Proposal for Shear Force Correction in CSR BC Rules

Fig.8 Cases 1a and 1b – Shear stress in the side shell around the neutral axis
in way of T.BHD between loaded and empty holds
(Alternate load condition)

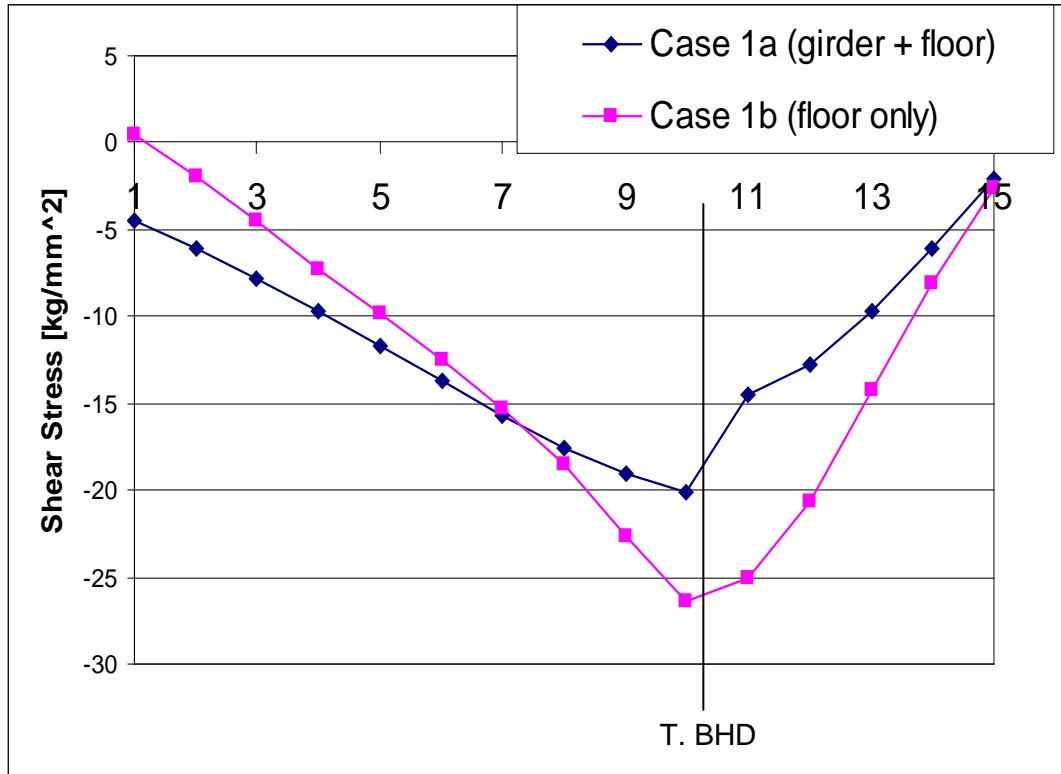
2.3 The FE model and results of shear stress in way of T.BHD between loaded and empty holds (Alternate load condition: Case 1a and 1b) are shown in Figs. 5 to 8. From Fig. 8, the phenomena of shear force correction is observed, which corresponds to the area marked in blue in Fig.2.

Fig.12 Cases 2a and 2b – Shear stress in the side shell around the neutral axis
in way of T.BHD between empty holds
(Heavy ballast condition)

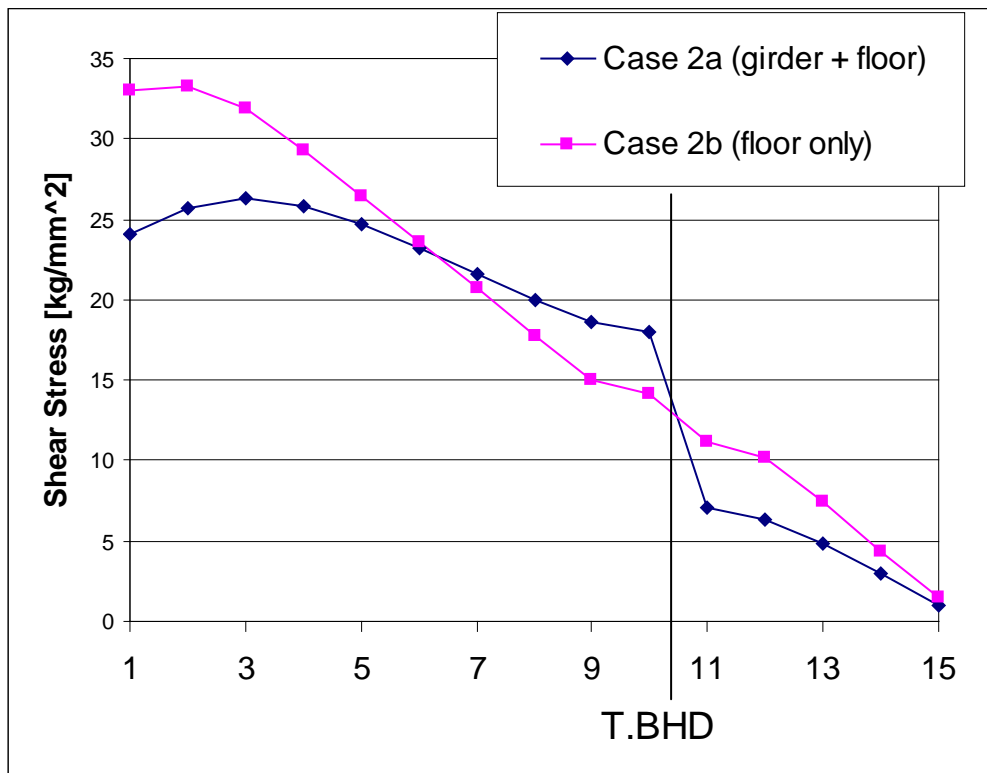
2.4 The FE model and results of shear stress for T.BHD between empty holds (Heavy ballast condition: Case 2a and 2b) are shown in Figs. 9 to 12. From Fig. 12, even at the transverse bulkhead between empty holds, the phenomena of shear force correction is observed, which corresponds to the area marked in blue in Fig. 4.

2.5 It is concluded that SF correction can be applicable to any loading conditions at any transverse bulkhead.

Fig.13 Shear force distribution with the current ϵ in CSR BC Rules for heavy ballast condition

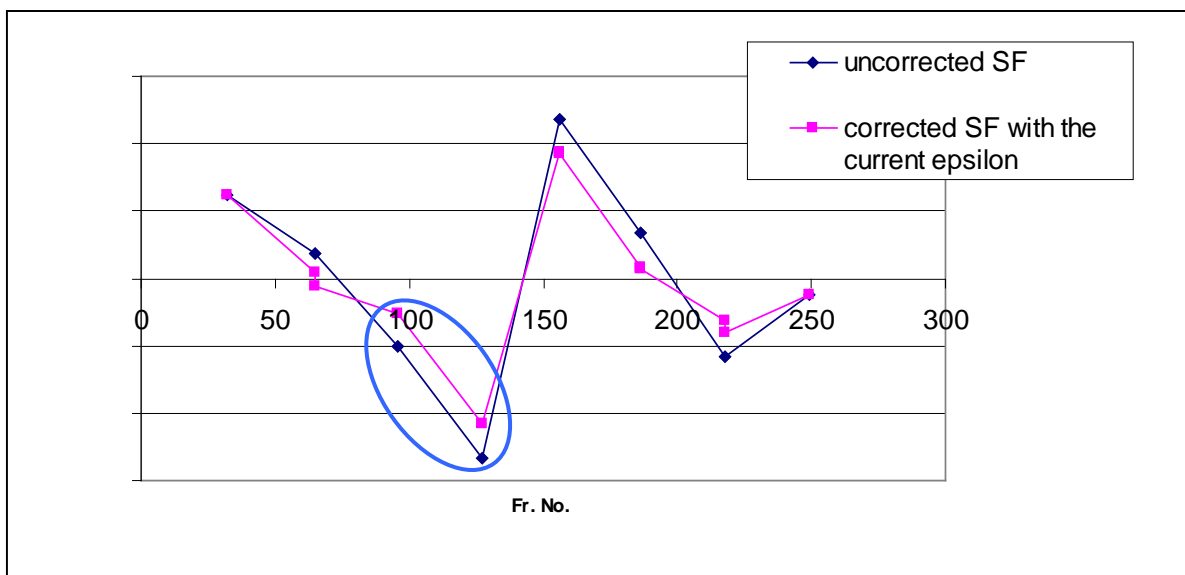
The latter case is shown as marked in blue in Fig.13. As can be seen, the lines representing SF values with and without SF correction is not crossed, which is inadequate in theory.

3.2 The inappropriate SF correction is caused by the definition of ϵ in Ch.5, Sec.1-2.2.2 of the current CSR BC Rules. In Fig.13, as both of the sign conventions are negative, both values of ϵ ($=\text{sgn}(Q_w)$) are minus one (-1) and hence both SF values are corrected upward.

3.3 Consequently, the following new definition of ϵ is proposed. Fig.14 shows the SF with the proposed ϵ , which is adequate in theory.

$\epsilon = \epsilon_A$, at the aft transverse bulkhead in the cargo hold considered, or
 ϵ_B , at the forward transverse bulkhead in the cargo hold considered.

$$\epsilon_A = \text{sgn}(Q_A - Q_B)$$

$$\epsilon_B = -\epsilon_A$$
